Access Compliance Report

Public Rights-of-Way

(Curb Ramps)

Intersection ID: N/A	Main Street: YORK_CENTER	Cross Street: N/A	Location: SE
ADA ID: 89D2C24EF2B3	Ramp Type: Perp	Initial Pass/Fail: Fail	Overall Compliance: No
Severity Score: 10			
Codes/Mitigation Info/Possible Solution		Field Measurements/Component Compliance

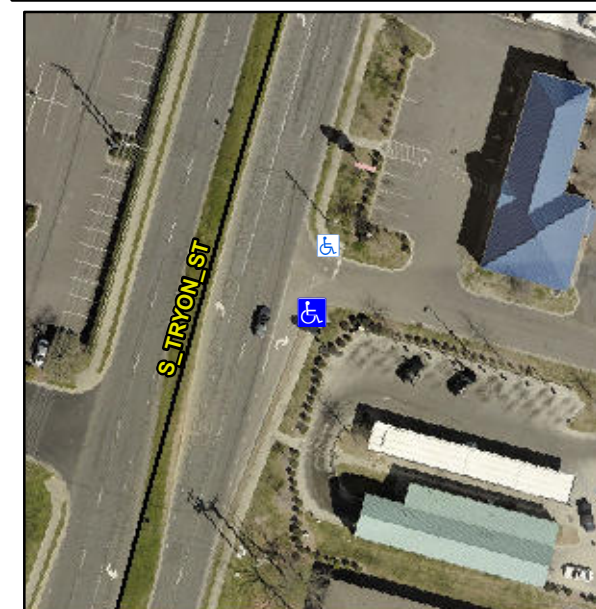
Not Found, R304.5.1, R304.5.3

Compliance	Description	Data	Compliance	Description	Data
N/A	Ramp Length (in)	91.0	Yes	Ramp Slope (%)	6.8
No	Ramp Width (in)	47.0	No	Ramp XSlope (%)	2.9
N/A	Flare Type LT	N/A	N/A	Flare Type RT	N/A
N/A	Flare Slope LT (%)	N/A	N/A	Flare Slope RT (%)	N/A
N/A	Flare Traversable LT?	N/A	N/A	Flare Traversable RT?	N/A
N/A	Landing Length (in)	N/A	N/A	DWS Provided?	N/A
N/A	Landing Width (in)	N/A	N/A	DWS Contrast?	N/A
N/A	Landing Slope (%)	N/A	N/A	DWS Length (in)	N/A
N/A	Landing X Slope (%)	N/A	N/A	DWS Full Width?	N/A
N/A	Landing Curb? (Y/N)	N/A	N/A	DWS Offset (in)	N/A
N/A	Shared Landing?	N/A			
N/A	Gutter Ponding?	N/A	N/A	Gutter Slope (%)	N/A
N/A	Gutter Lip Ht (in)	N/A	N/A	Gutter X Slope (%)	N/A
N/A	Painted X Walk1?	Yes	N/A	Painted X Walk2?	N/A
	X Walk 1 Direction	To N		X Walk 2 Direction	N/A
N/A	X Walk 1 Width (in)	54.0	N/A	X Walk 2 Width (in)	N/A
	X Walk 1 Slope (%)	0.5		X Walk 2 Slope (%)	N/A
	X Walk 1 X Slope (%)	2.4		X Walk 2 X Slope (%)	N/A

**Remove & Replace Entire Ramp.
Restripe Crosswalk.**
